BALTIMORE COUNTY, MARYLAND
INTER-OFFICE MEMORANDUM

SUBJECT: CONCEPT PLAN CONFERENCE
Project Name: Southern Crossroads
PAI #XIII-239

CONCEPT PLANS FOR SOUTHERN CROSSROADS

Figure 3: Example of mid-block sidewalk passages within a townhouse grid layout.

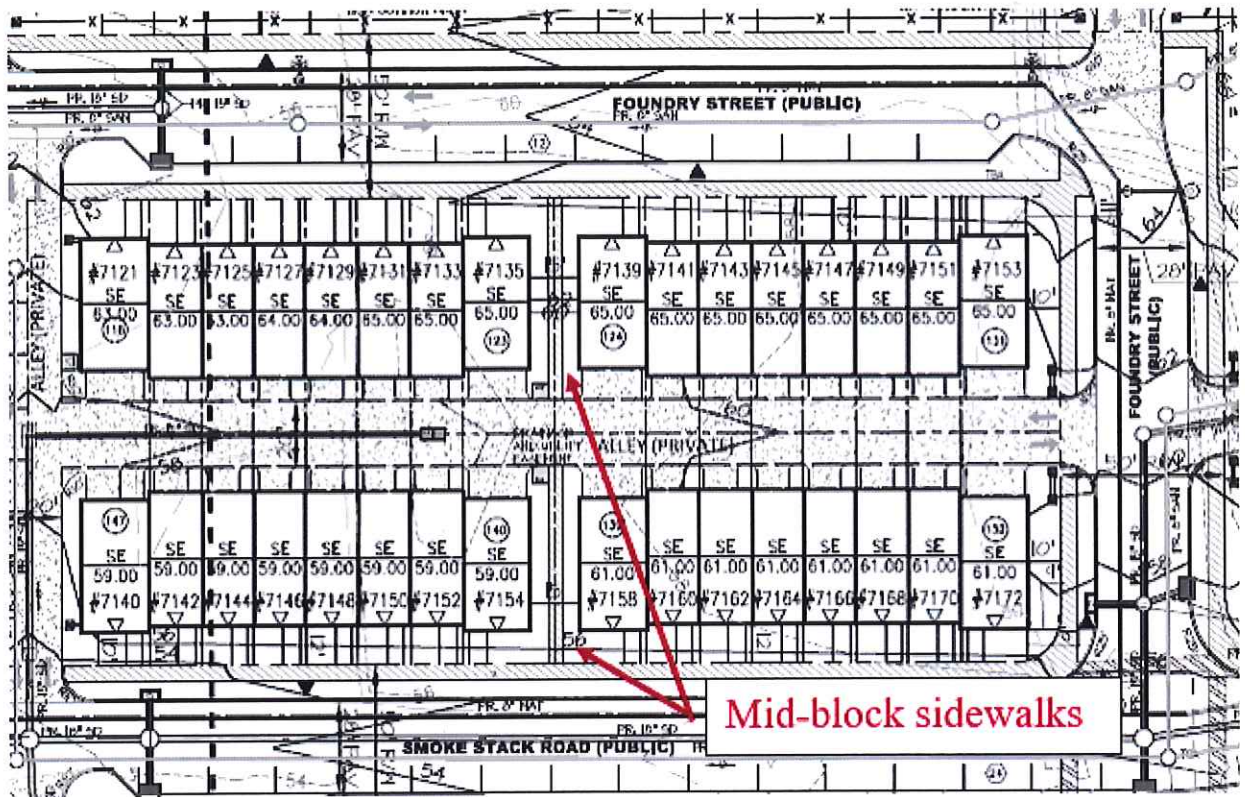
- h. Eliminate Lots 120-123 and Lots 150-153 in order to continue and connect the street and sidewalk of Road C eastward to Road B (see sheet C-304 of plan markup). As the general layout of the development is proposed in a grid pattern consistent with the urban residential fabric environment of the T4 transect, the provision of this east-west connection will further provide pedestrian and vehicular connectivity to the development and will support the objectives of *Master Plan 2020* in providing a compact walkable community in which increased road connectivity including shorter blocks will be provided (Page 201). In addition to this street connection, provide mid-block sidewalk pathways in order to provide further connectivity. See graphic below for an example of such pathways. This graphic is from the Foundry Station PUD development plan, and such plan provides positive examples regarding central focal open spaces, greens, and play areas integrated within a similar grid pattern. Future plan submittals for the subject development should incorporate such elements.

SITE PROPOSAL PLAN
 SHEET NUMBER **C-303**
 ORIG. DATE: 05/20

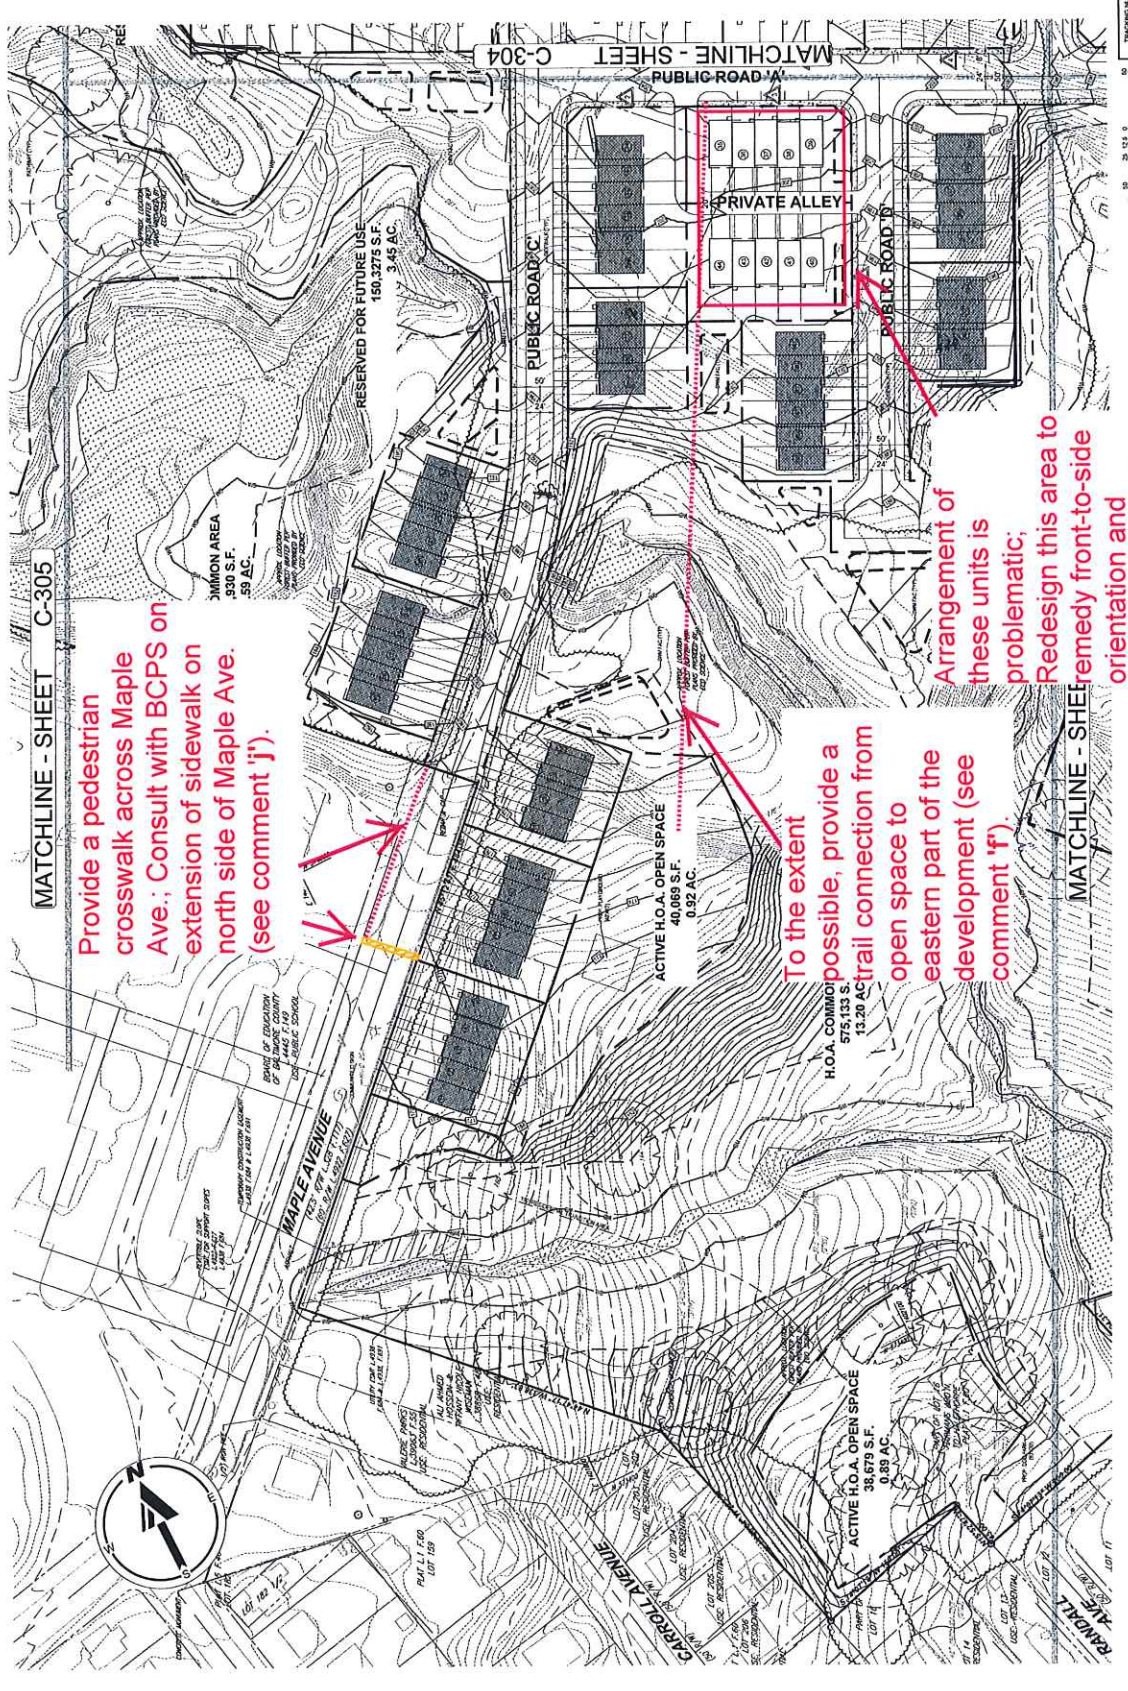
The developer should coordinate with BCPS to ensure that an extension of the sidewalk on the north side of Maple Avenue to the sidewalk proposed within the development is provided (See sheet C-303 of plan markup). The developer should further supply a pedestrian crosswalk across Maple Avenue in order to connect pedestrians to the proposed Lots 1-14. Provision of these pedestrian connections will further realize the goals of connectivity expressed in the county's, "Complete Streets" policy document, most notably its site design goal of, "design the circulation network to facilitate connections between uses within the project and to the surrounding area by walking and bicycling as well as by driving (page D-2 of Complete Streets document).

- i. Revise the layout of lots 39-44 (see sheet C-303 of plan markup) in order to avoid the front-to-side orientations and to provide additional active open space/ tot-lot near the surrounding dwellings to invite use thereof, as described in Section B., Residential Guidelines, Open Space, (Page 51). A preferred layout would be to reorient lots 40-44 to front Road D while eliminating Lots 35-39; this would allow for units to have increased rear yard space and allow for additional HOA open space behind such units.

- k. Areas of extensive grading, particularly located on private lots should be avoided to the greatest extent possible, such as on Lot 60 shown on sheet C-303. The development should be designed in concert with the existing grades as indicated in Division 2, Section B, Residential Guidelines, Site Planning section of the CMDP (pages 43-45). Provide a narrative with cross-sections of existing vs. proposed grades to demonstrate how the dwelling units will follow the proposed grades and how mass grading of the tract will be avoided.

- o. Show how the proposed playground on sheet C-303 will be accessed. The plan should further provide increased opportunities for pedestrian activity and connectivity throughout the development, particularly from open space areas to the proposed sidewalks along the public roads.

Provide a pedestrian crosswalk across Maple Ave.; Consult with BCPS on extension of sidewalk on north side of Maple Ave. (see comment 'j').

To the extent possible, provide a trail connection from open space to eastern part of the development (see comment 'f').

Arrangement of these units is problematic; Redesign this area to remedy front-to-side orientation and provide additional open space (see comment 'i').
